## Attachment 4

### *Discussion Supplemental Information*

## **DISCUSSION - SUPPLEMENTAL INFORMATION**

*Figure 2: Applicant Analysis of Adjacent Development Potential*

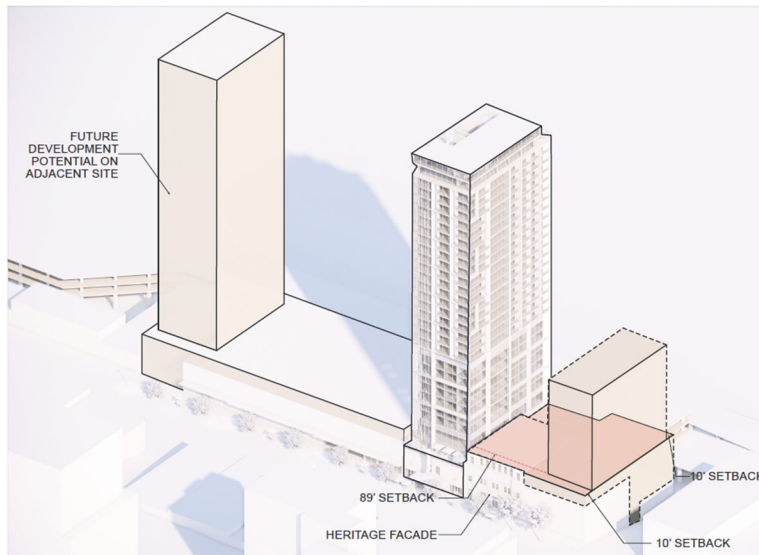
The applicant has prepared an analysis of the development potential of the adjacent sites. The analysis demonstrates that the mid-block tower limits the overall development potential for the block, particularly on the properties to the west where achieving tower

separation would result in an exceptionally narrow (40.97 feet) and likely impractical tower footprint.

As a result, it is likely that if these properties were to develop, they would be limited to a low-rise form.

Design adjustments, such as introduction of a zero lot line condition above the third storey, could improve adjacent development by allowing more development on the podium levels. This approach would likely result in fewer hotel units on the lower levels.
